Date: Updated Report: August 30, 2022
 To: Planning and Zoning Board (P&Z)
 From: Ellen Hardgrove, City Planning Consultant
 XC: Sandy Riffle, Interim City Clerk
 Brett Sollazzo, Administrative Assistant
 Drew Smith, City Attorney
 Allen Lane, City Engineering Consultant
 Re: ECD Waivers Related to Proposed Car Wash at 4800 South Orange Avenue.

REQUESTED WAIVERS

Exhibit 3 – Proposed Car Wash Layout

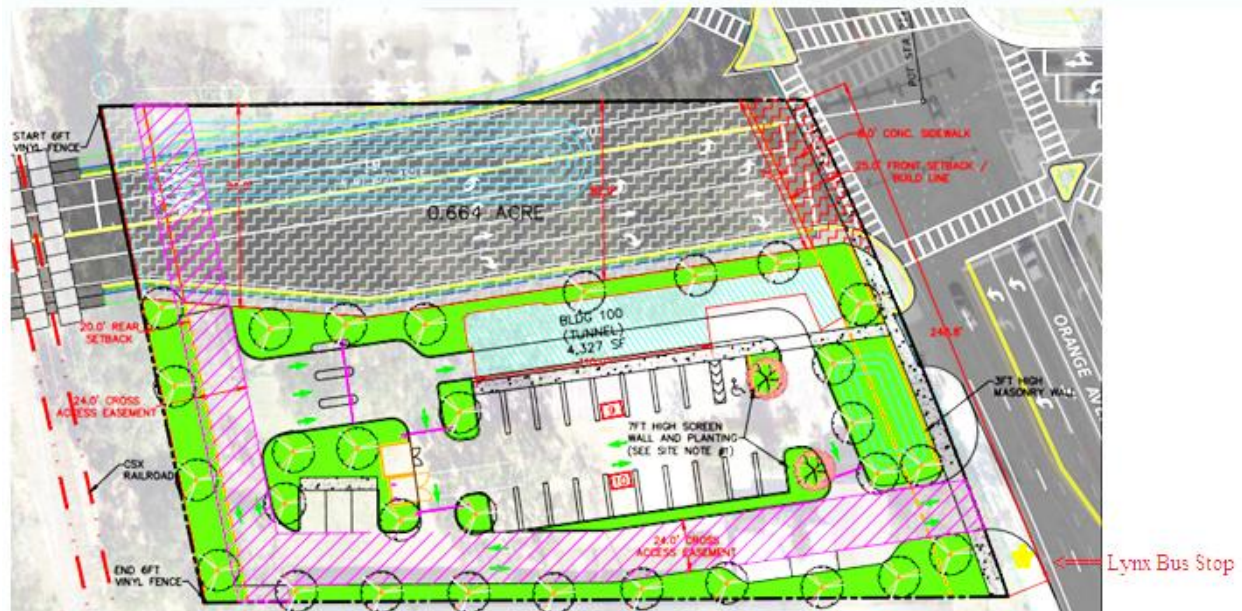
The primary waiver requested is to allow the building to only face 11.25% of the Orange Avenue frontage (28 feet building frontage with 248.8 feet lot width) instead of the required 70% (Code Section 134-468(f)). The premise for the waiver, according to the applicant, is to help achieve the City's goal to provide a solution to the traffic issues created by Holden/Orange/Gatlin Avenues offset intersections by limiting the development to the southern 2/3's of the property to preserve the north 1/3 for a potential Holden Avenue realignment.

With use of the waiver, the applicant would build the car wash tunnel/building perpendicular to Orange Avenue and use the north 1/3 of the property only for stormwater management. If Holden Avenue is realigned, the idea is to accommodate the stormwater from the car wash into the road's stormwater management system. Exhibit 3 shows the proposed site layout with the conceptual alignment for the Holden Avenue realignment as shown in Orange County's Intersection Analysis Study (November 2021) superimposed over the car wash site layout.

A waiver would still be needed if that portion of the property were already acquired for the realigned road; the proposed building frontage would account for only 16% of the property frontage, still significantly substandard for the ECD requirement.

Any consideration of approval of this requested waiver should be conditioned on preservation of obtaining the ECD goal of creating interest for pedestrian activity. There are likely many creative ideas.

One idea could be creating a park like setting in the ±45x70 feet green space proposed between the driveway and the building, setting back the street wall along the west side of that green space and providing street furniture, bike parking, and enhanced landscaping. A Lynx bus shelter could be incorporated into the green space; the bus stop current location will need to be relocated if this site plan is implemented as the current location would be on edge the driveway's radius connection to Orange Avenue. The shelter could be accommodated within an expanded urban services easement. Based on the estimated distance between the back of Orange Avenue curb

and property line, the easement will be needed to accommodate the minimum six feet grassed strip and the eight feet wide unobstructed sidewalk width along Orange Avenue; thus, there is not a burden to creating the easement for the Lynx shelter.

Furthermore, given the premise of the waiver is to accommodate a future Holden Avenue realignment, the north side of the site/building should be required to be designed in anticipation of the new road. The ECD standards including the People Space and building design are not met as currently proposed.

The ECD requires buildings facing Holden Avenue to be constructed at the “build line.” This provides a 25 feet wide green buffer to accommodate shade trees spaced 35 feet on center for an aesthetic as well as shaded pedestrian path. The proposed building is situated only 5-7 feet from what is shown as the future Holden Avenue right-of-way line; this is not only inconsistent with the ECD requirements, but shade trees in this narrow space would cause future damage to sidewalks and the building.

Another strong staff recommendation if P&Z recommends approval is to attach conditions detailing 1) the development will meet the goal of creating pedestrian interest along the Orange Avenue frontage such as provision of a park-like setting along the Orange Avenue frontage between the building and the driveway and incorporation of the Lynx bus shelter, and 2) how the north elevation, along the potential future Holden Avenue alignment, will be innovatively designed to meet the ECD building design/People Space standards as discussed within this report.

Exhibit 6 – Proposed Vacuum Screen Wall Locations

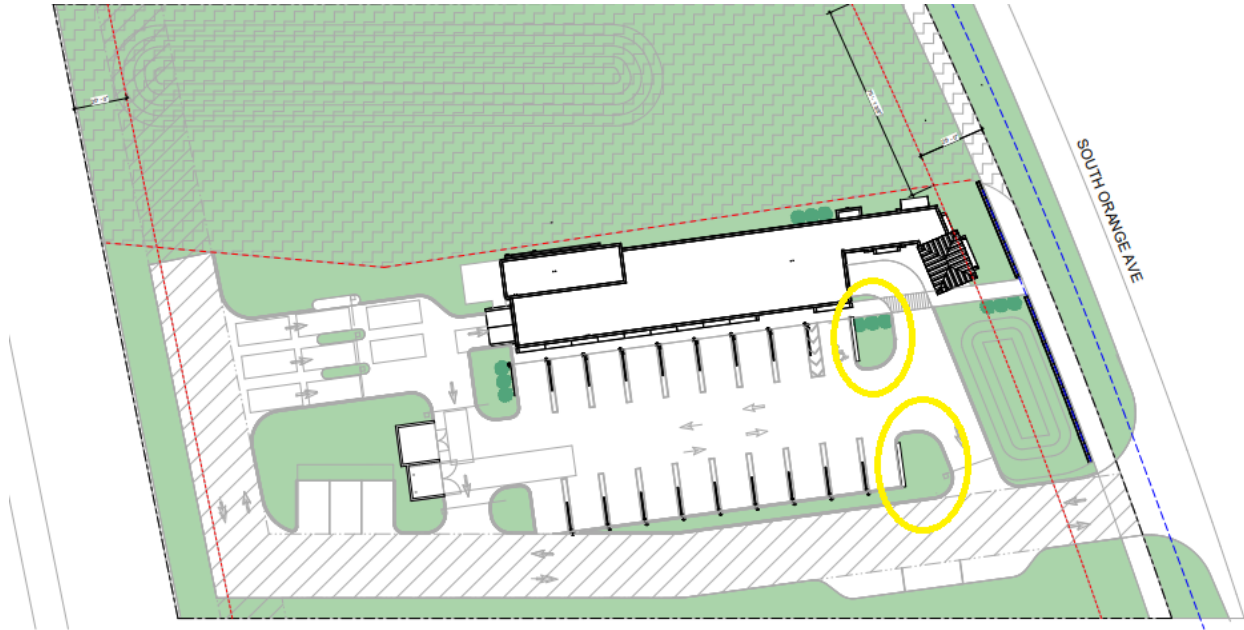
- **A waiver to allow the vacuum stations to be screened from Orange Avenue with an alternate design than that required by Code Section 134-472(a)(4).** The applicant is proposing a 7 feet high masonry stucco wall matching the colors of the building at the east end of each row of vacuum parking stalls as shown in Exhibits 6 and 7. ECD design standards require those walls to be consistent with ECD front elevation standards such as, but limited to, window transparency and avoidance of blank walls. The applicant justifies the need for this waiver as a consequence to turning the building in order to preserve the northern 1/3 of the property for the Holden Avenue realignment.

To minimize the blank wall aesthetic, the applicant is proposing a magnolia tree, 3 inch caliper/12 feet high at planting, to be placed in front of each wall plus a hedge along the entire length. It should be noted that the City's Landscape Architect has concerns related to the viability of the hedges in this location: the hedges will not receive enough sunlight with a wall blocking all the afternoon sun and magnolia trees blocking most of the morning sun.

If the waiver for screening the vacuum stations from Orange Avenue is approved by P&Z, staff recommends a condition of approval be attached to 1) require the walls compliment the building materials/colors and 2) the trees and the other landscaping be approved by the City’s Landscape Architect, with the trees being a minimum 3” caliper/12 feet in height at planting unless otherwise allowed by the City’s Landscape Architect.
